5502 4th St NW

60-Day Temporary Certificate of Occupancy- Transportation Development

Project Title: Dunkin Donuts Renovation	_Building Permit #:T2016 EPC#:	——————————————————————————————————————
Legal Description: 008 Linda Vista Addn #	Antonia advanta and the old to the shiphigh the hall the state of the shiphing and the ship	Work Order#:
City Address: 5502 4th Street NW		
Applicant: R2 Architectural		Contact: Robert Rayner
Address: 730 San Mateo Blvd SE		minimum manimum manimu
Phone#: 505-321-3932	Fax#: 505-792-6224	E-mail:
rob@r2architectural.com		
Other Contact:		Contact:
Address:		
Phone#:	Fax#:	E-mail:
Check all that Apply:		
DEPARTMENT: HYDROLOGY/ DRAINAGE  XTRAFFIC/ TRANSPORTATION MS4/ EROSION & SEDIMENT CONTROL  TYPE OF SUBMITTAL: ENGINEER/ARCHITECT CERTIFICATION	X CER  X PRE  SITI	OF APPROVAL/ACCEPTANCE SOUGHT: FEDENG PERMIT APPROVAL RTIFICATE OF OCCUPANCY ELIMINARY PLAT APPROVAL 'E PLAN FOR SUB'D APPROVAL 'E PLAN FOR BLDG. PERMIT APPROVAL
CONCEPTUAL G & D PLAN  GRADING PLAN  DRAINAGE MASTER PLAN  DRAINAGE REPORT  CLOMR/LOMR	SIA/ FOU  GRA	IAL PLAT APPROVAL  / RELEASE OF FINANCIAL GUARANTEE  JNDATION PERMIT APPROVAL  ADING PERMIT APPROVAL  19 APPROVAL

**Traffic Circulat

Figure 1. Mini Clear Sight Triangle

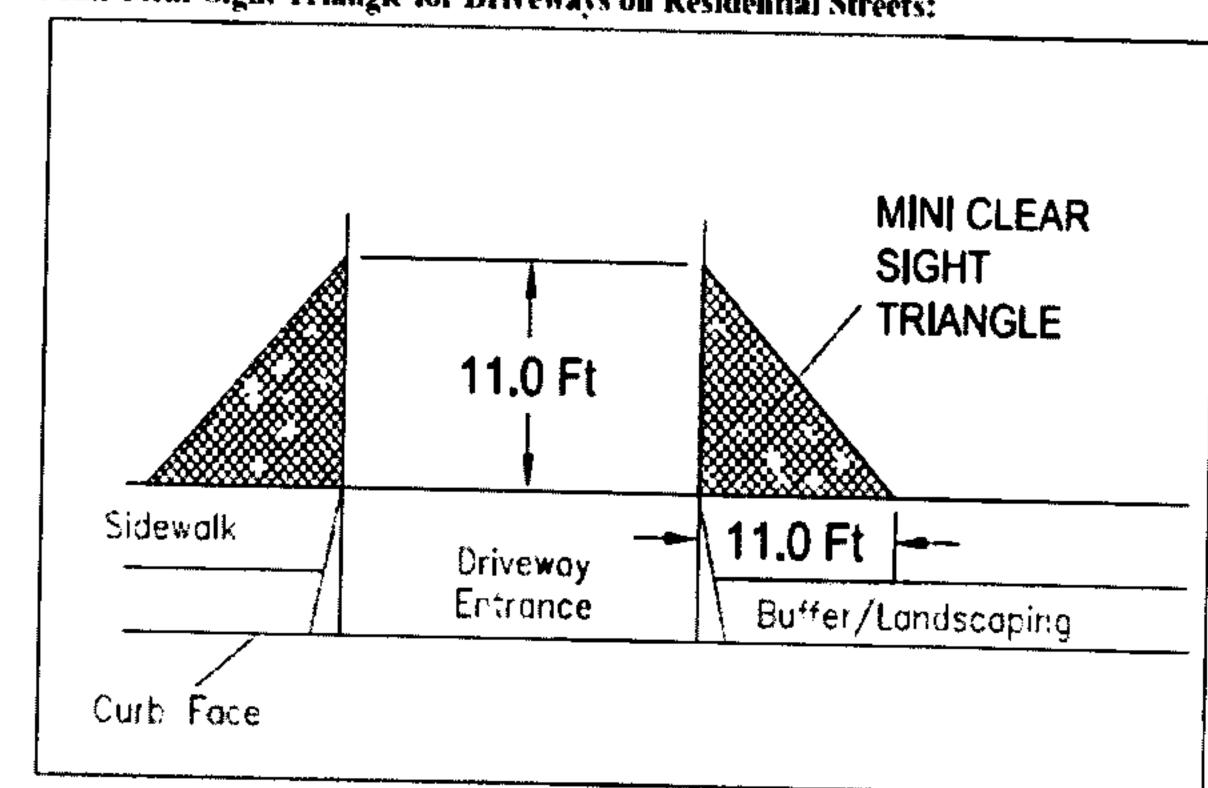
- 10. Provide a min 6" or max 8" high concrete barrier curb or other acceptable barrier between landscaping and parking areas and/or drive aisles. Please call out detail and location of barrier curb.
- Service vehicle and/or refuse vehicle maneuvering must be contained on-site; provide a copy of refuse approval.
- One-way vehicular paths require pavement directional signage and a posted "Do Not Enter" sign at the point of egress. Please show detail and location of posted signs.
- Please provide a sight distance exhibit (see the Development Process Manual, Chapter 23, Section 3). Please show this detail for the intersection of 4th St. and Sanchez Rd. Please show the Mini Clear Sight Triangle detail for the other entrances off of 4<sup>th</sup> St. and Sanchez Rd.

- Please add the following note to the clear sight triangle: "Landscaping and signage will not interfere with clear sight requirements. Therefore, signs, walls, trees, and shrubbery between 3 and 8 feet tall (as measured from the gutter pan) will not be acceptable in this area."
- Unused curb cuts must be replaced with sidewalk and curb & gutter. A build note must be provided referring to the appropriate City Standard drawing.
